**Proposal for a corrigendum to a UN GTR, if any**

## **Proposal for Corrigendum 1 to UN Global Technical Regulation No. 13 (Hydrogen and Fuel Cell Vehicles)**

### **Submitted by the Working Party on Passive Safety\***

"Figure 3  
Drop Orientations

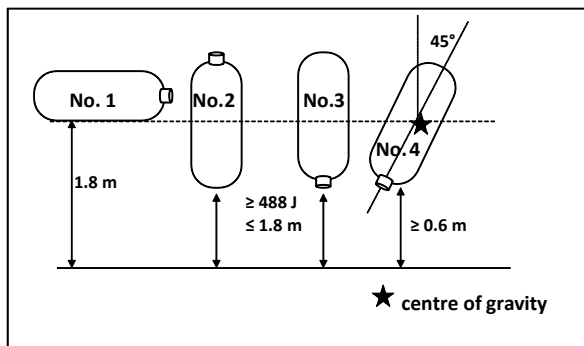
Figure 3 in paragraph 6.2.3.2., amend to read (correct the place of words in the drawing):

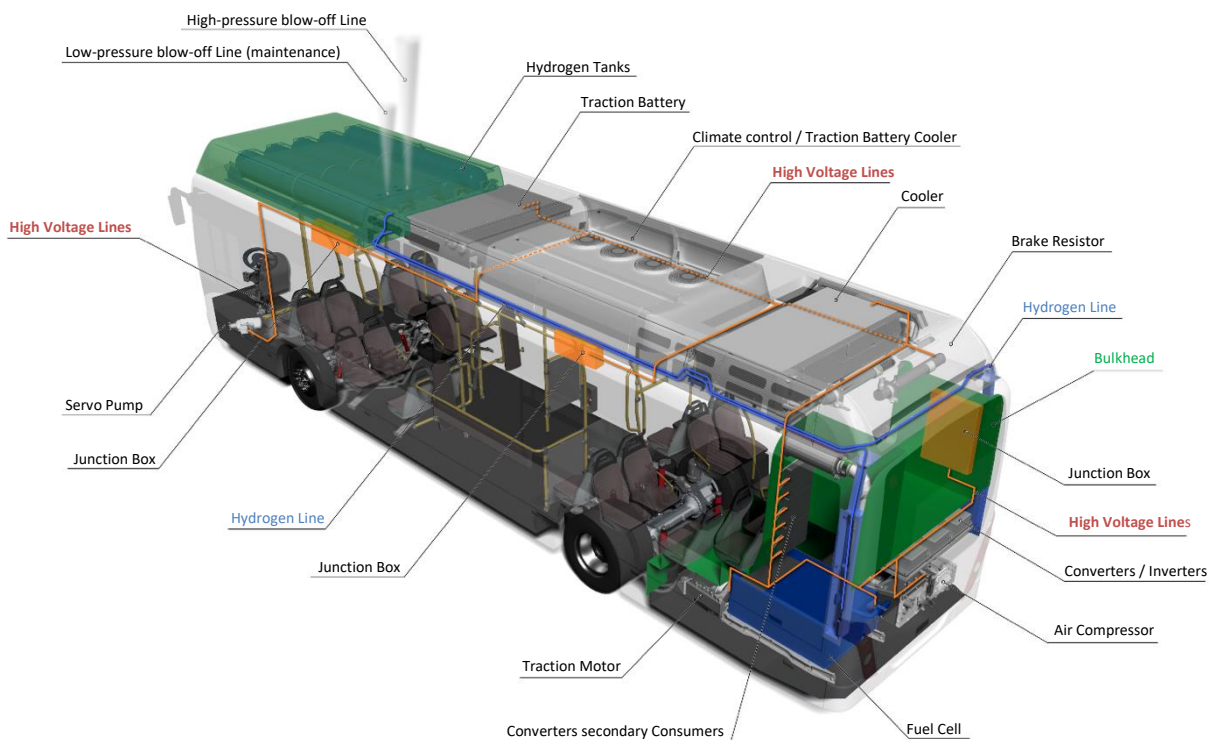
Figure 3 (Example of a hydrogen fuel cell bus), three labels of "High Voltage Lines", amend to read:

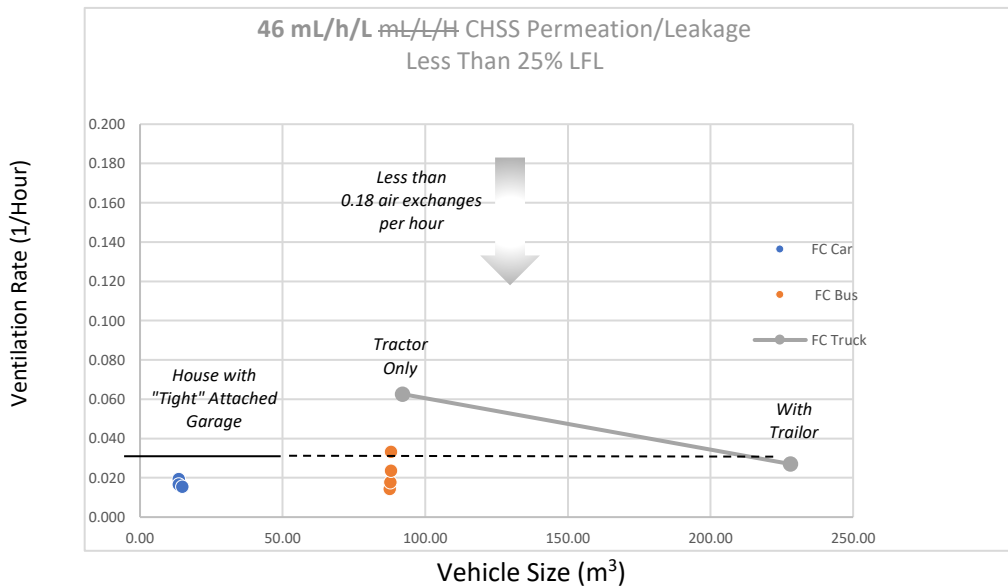
Figure 10, amend to read (such that x-axis label is consistent with the paragraph above it):

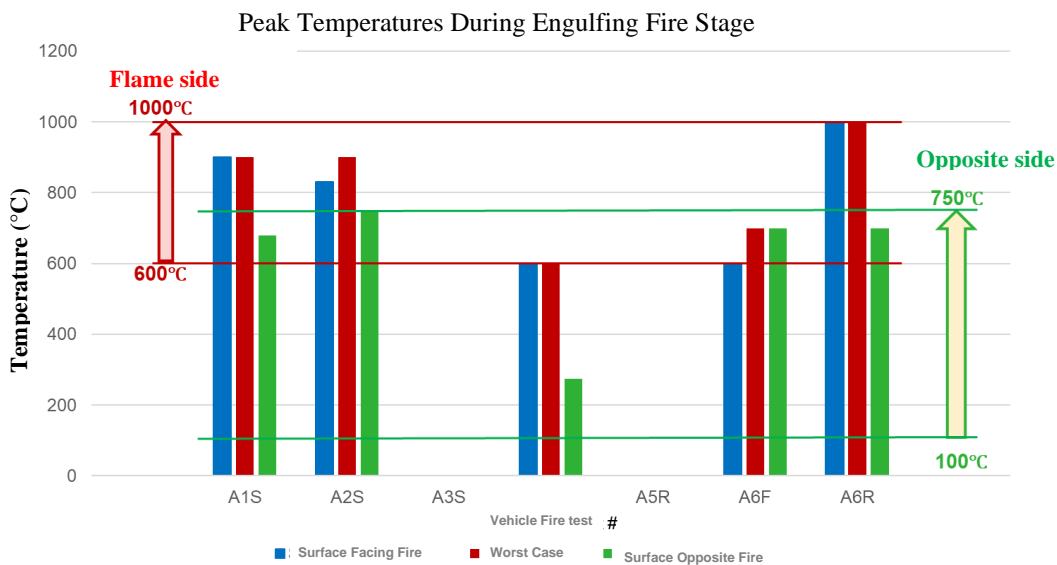
Figure 12 in paragraph 88, amend to read (corrected labels, no changes to values):
